## Swingaway Pty Ltd

RE: SSI-57056461 COWARRA WATER SUPPLY SCHEME

Figure 2: Extract from DP 776844

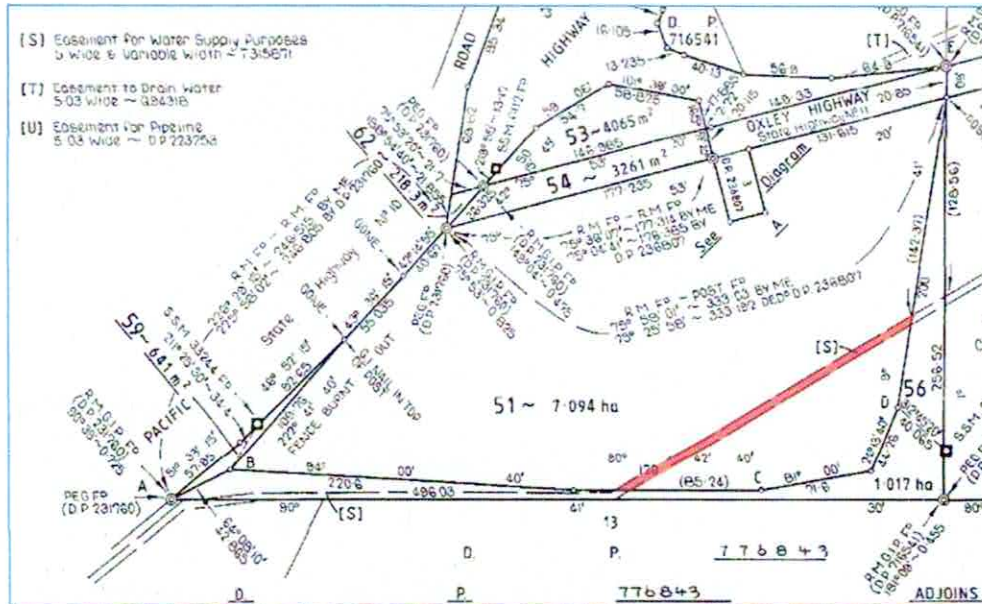
Following as Figure 2 is an extract from DP 776844 identifying the subject lots and the existing Easement for Water Supply Purposes 5 Wide and Variable Width (highlighted red) which encumbers Lot 51 DP 776844. Further, Figure 2 identifies that this easement (and therefore potentially the route of a watermain) also encumbers the adjoining Lot 56 DP 776844, which we understand was dedicated as road reserve and now forms part of the Oxley Highway.

In this regard, we confirm our support for not crossing the property within the site of the existing easement and seek further information illustrating where the proposed NATM will be located with respect to the property boundaries. With respect to the location of the NATM we confirm that it is our preference that it is located within the adjoining road reserve (partly being Lot 56 DP 768844 in Figure 2) and not on Lot 51 DP 768844.

Figure 4: Extract from Figure 3.7 of the Environmental Impact Statement

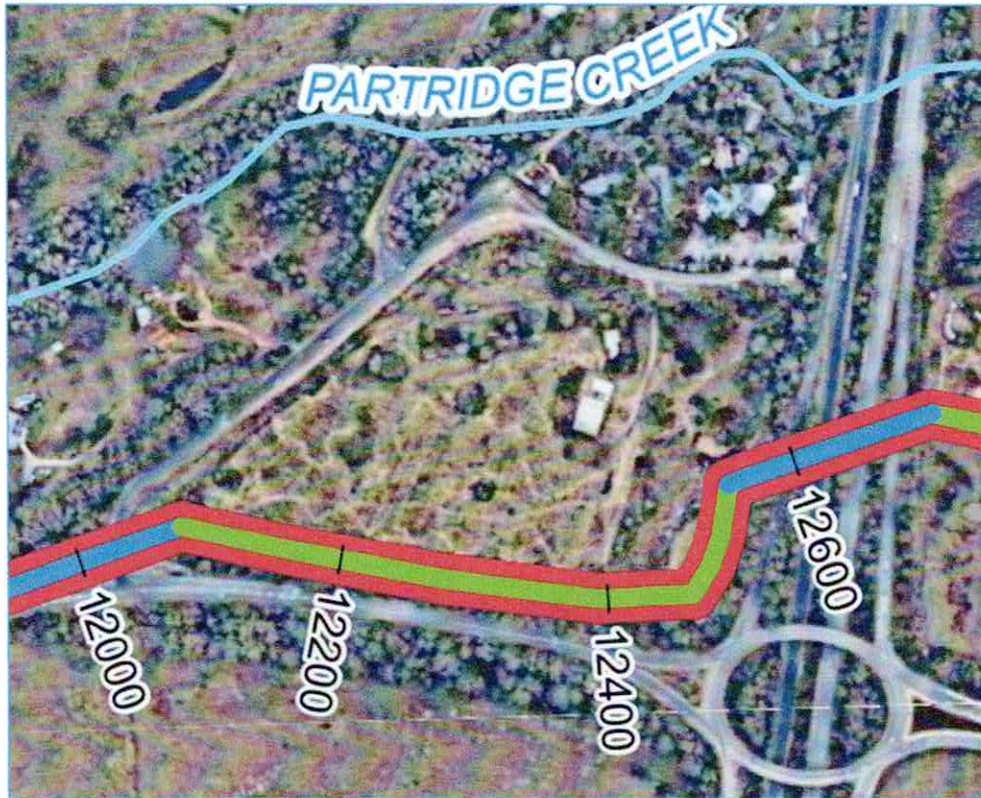
Figure 3.7 of the Environmental Impact Statement (EIS) identifies that the proposed route of the NATM will no longer cross the southeastern corner of the property and instead will follow the Oxley Highway and Pacific Highway property boundaries (refer Figure 4 below).
